# Intel<sup>®</sup> 80219 General Purpose PCI Processor

## Specification Update

*July 2004*

Document Number: [274020-002](#)

**Figure 2. Intel® 80219 General Purpose PCI Processor P\_BMI Signal Implementation for Intel® 80219 General Purpose PCI Processor B-0/B-1 Stepping**

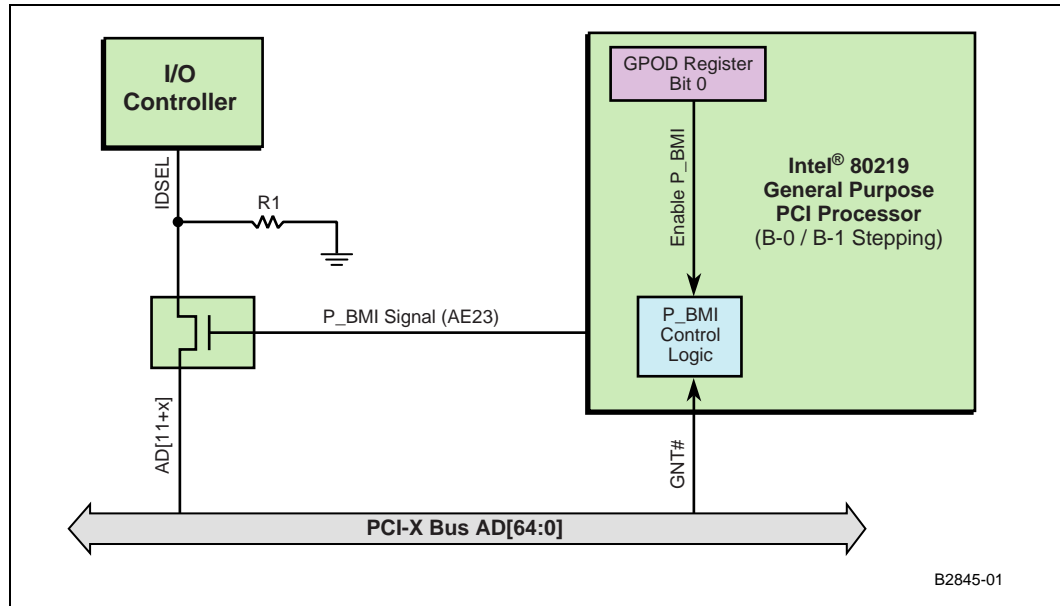
## 1. Signal NC2 was renamed to P\_BMI (AE23). New function added to signal P\_BMI.

The P\_BMI (AE23) signal has been added to the Intel® 80219 general purpose PCI processor. This signal replaces, using an external GPIO pin for Initialization Device Select (IDSEL) control of an I/O device during host configuration cycles.

Issue: I/O Device IDSEL control using the new P\_BMI signal:

The 80219 has eight integrated General Purpose Input Output (GPIO) pins, referred to as GPIO[7:0]. These pins, along with the new PCI-X Bus Master Indicator (P\_BMI) signal, can be used to control the IDSEL to the I/O device. External circuitry is no longer required other than a simple switch. The output function of the P\_BMI signal is controlled by the GPIO Output Data Register (GPOD), Bit 0 as shown in Table 1. The P\_BMI signal is always driven and defaults to driving low at power up.

The IDSEL signal is used as a chip select during configuration cycles initiated by the BIOS, operating system or 80219. The GPOD[0] can be driven low in firmware, thereby disabling the P\_BMI signal and hiding the host I/O device from the system, by turning off its IDSEL. When the 80219 intends to perform configuration cycles in the PCI bus segment of the I/O device, the P\_BMI signal should be asserted high by driving the GPOD[0] high. The affect of these two operations is, that the I/O device is initialized and controlled by the 80219. More care must be taken with the gate chosen to control IDSEL, since most host bridge controllers do not use PCI address stepping. With IDSEL being a synchronous signal, with respect to CLK, the switch used must be a sub nanosecond propagation delay device (e.g., Pericom PI5C3303). In Figure 2, the P\_BMI signal is used to control a MUX/DeMUX switch that is used to enable/disable IDSEL to the I/O device.

*Note:* The host BIOS does not require any modifications to accommodate this implementation. All the responsibility for I/O device configuration and resource falls to the 80219 firmware.
